UNITED STATES PATENT AND TRADEMARK OFFICE

APPLICATION NO.	FILING DATE	FIRST NAMED INVENTOR	ATTORNEY DOCKET NO.	CONFIRMATION NO.
10/666,905	09/19/2003	Alexander William Hasircoglu	18060 (AT 20958-02113)	8518
7590	05/02/2007			
Robert Kapalka Tyco Electronics Corporation Suite 140 4550 New Linden Hill Road Wilmington, DE 19808			EXAMINER CHANG, RICK KILTAE	
			ART UNIT 3726	PAPER NUMBER
			MAIL DATE 05/02/2007	DELIVERY MODE PAPER

Office Action Summary	Application No.	Applicant(s)	
	10/666,905	HASIRCOGLU ET AL.	
	Examiner Rick K. Chang	Art Unit 3726

DETAILED ACTION

Sheet 1 of 5

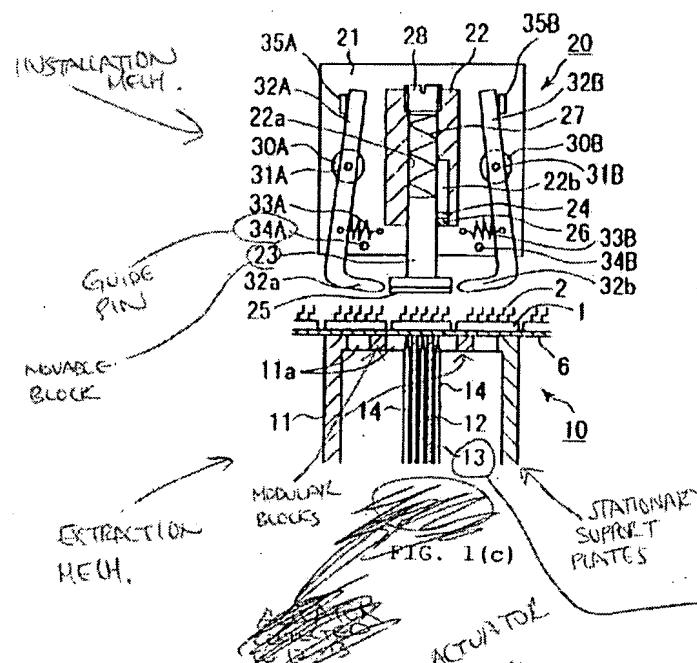
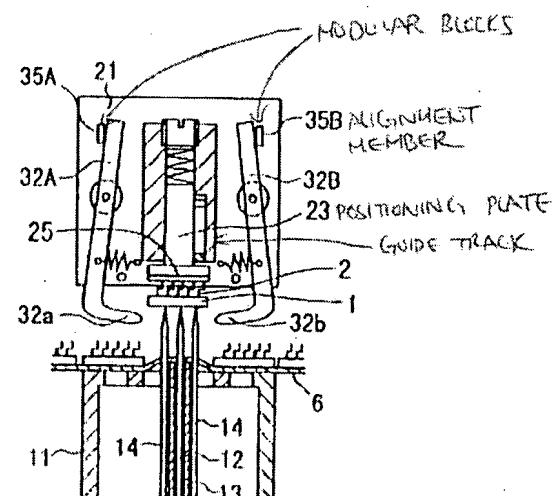
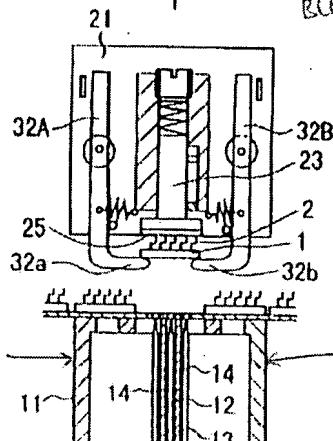
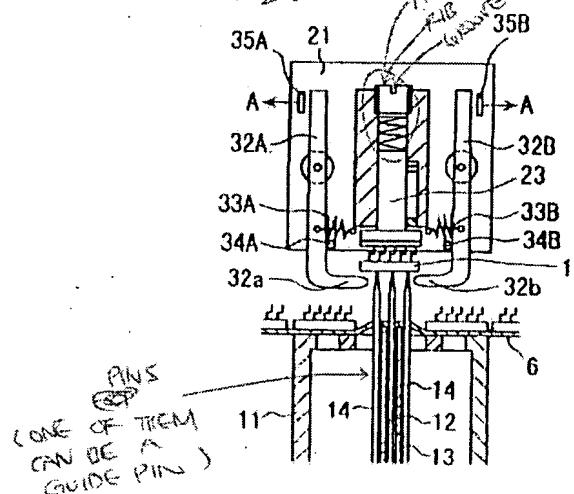
5. Claims 1-2, 4-9 and 22 are rejected under 35 U.S.C. 102(e) as being anticipated by

Mimata et al (US 6,505,397).

Mimata discloses as follows:

ACTUATOR
MOBILE HELD
BETWEEN FRONT
AND REAR SUPPORT
PLATES AND
BETWEEN THE
BLOCKS

* THE FLOOR OR THE EARTH OR THE BUILDING OR THE AIR
 WHERE THE ACTUATOR APPARATUS IS LOCATED
 IS SITUATED IN A NONCONDUCTIVE SECTION SOMEWHERE
 ADJACENT TO THE ACTUATOR
 4/26/07, EAST Version: 2.0.3.0
